**ADDENDUM NO. 2**  
**21<sup>ST</sup> AVENUE SW PRESERVATION PROJECT**  
**PROJECT #36253**

**ATTENTION ALL BIDDERS AND PLANHOLDERS:** You are hereby notified that the Bid and Contract Documents are amended as follows:

**ROADWAY & CHANNELIZATION 1**

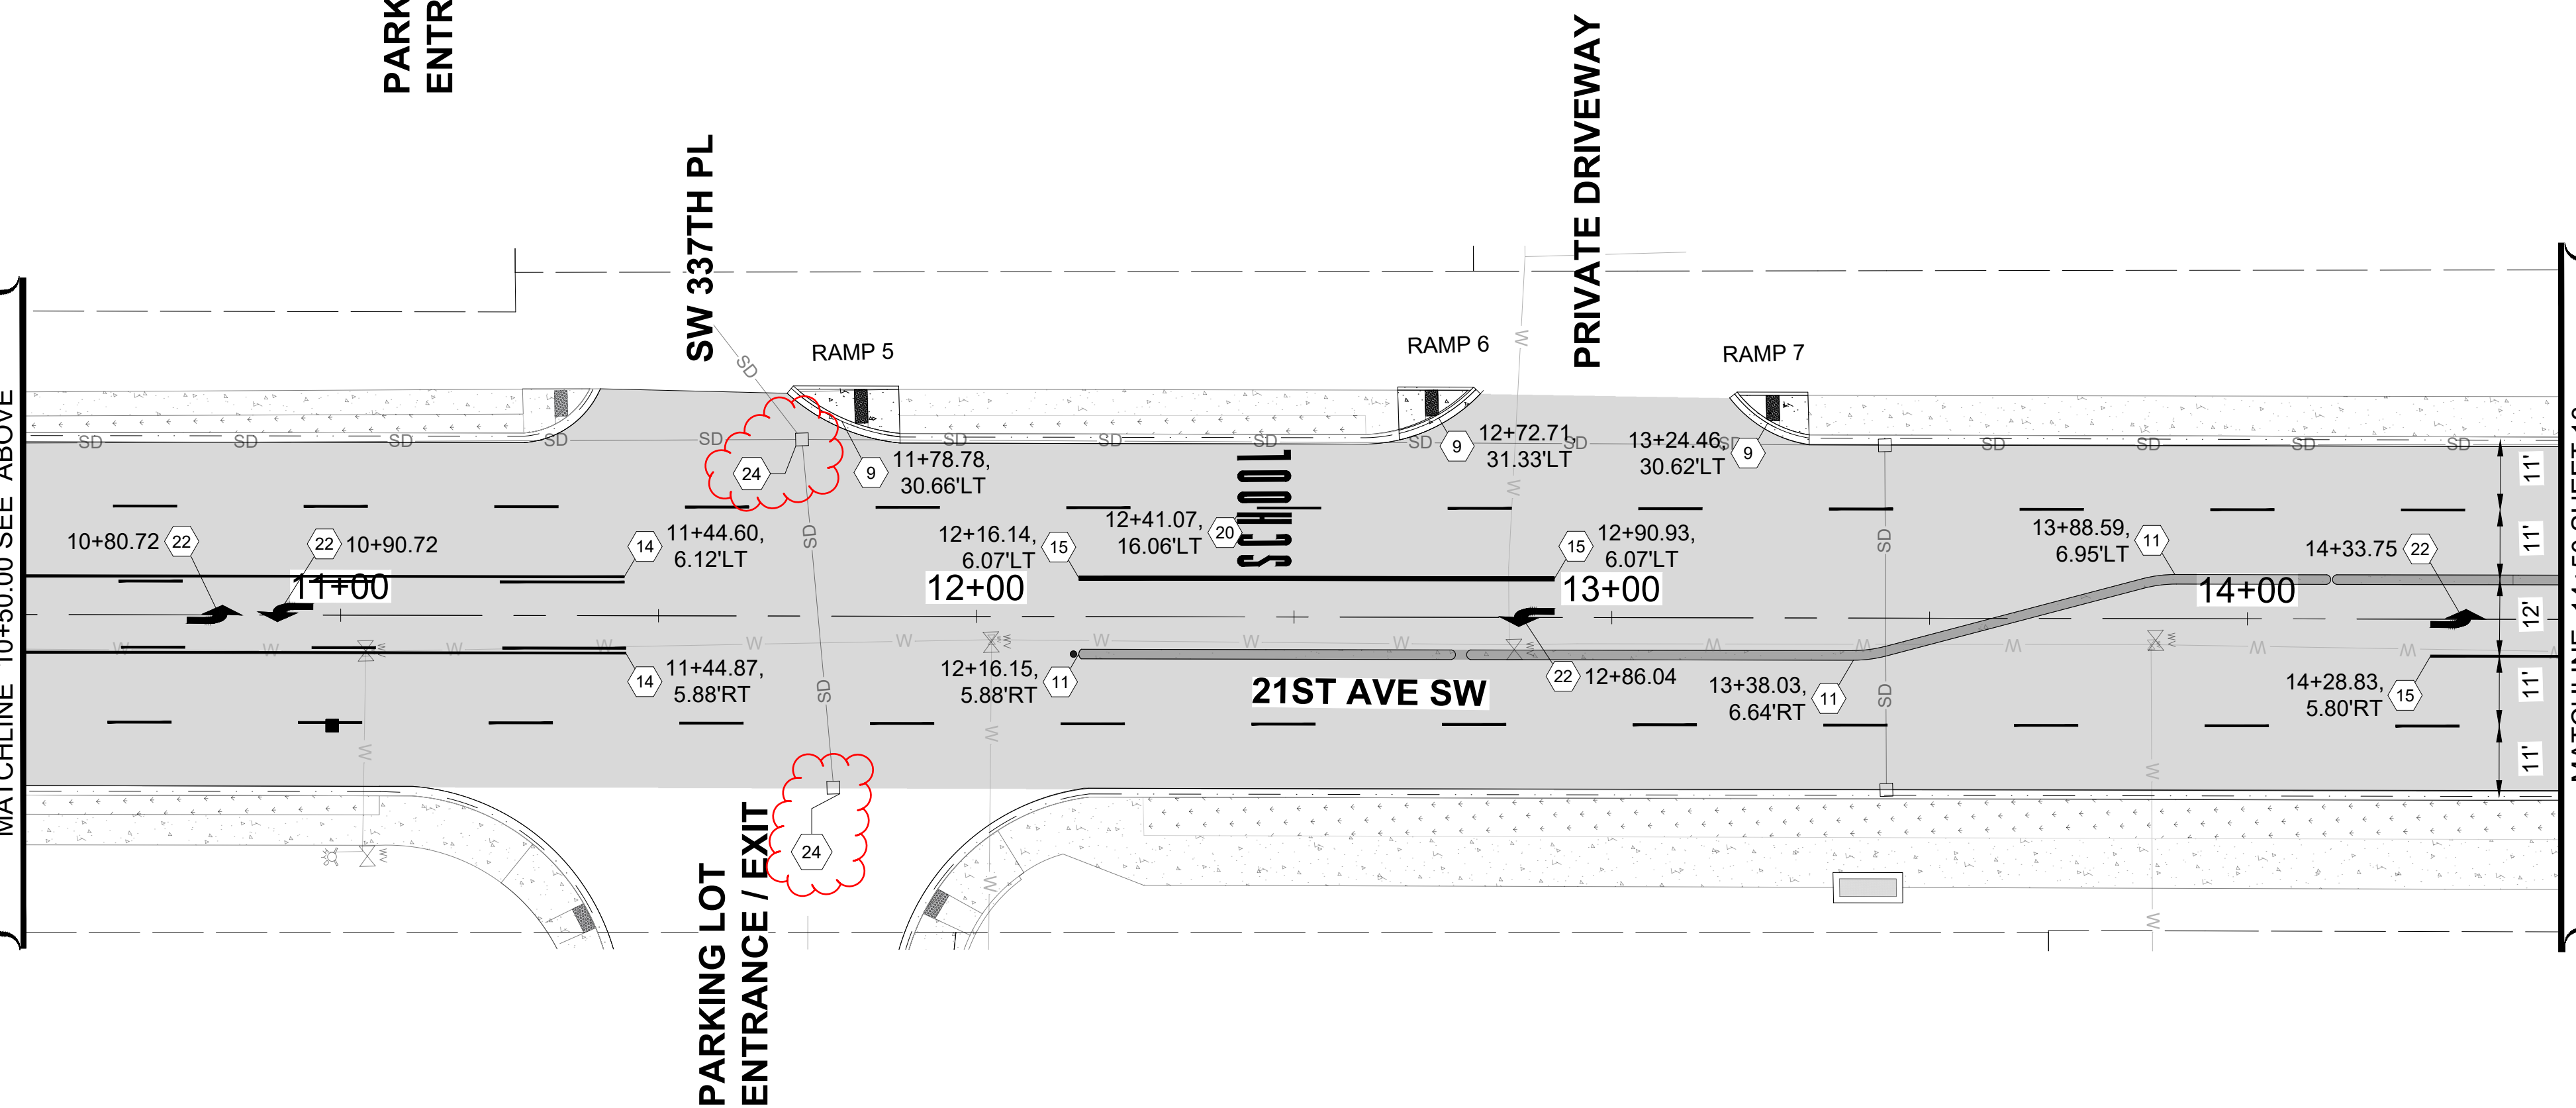
- The sheets have been revised to add callouts to identify catch basins to be adjusted.
- The sheets have been revised to clarify the electrical work.
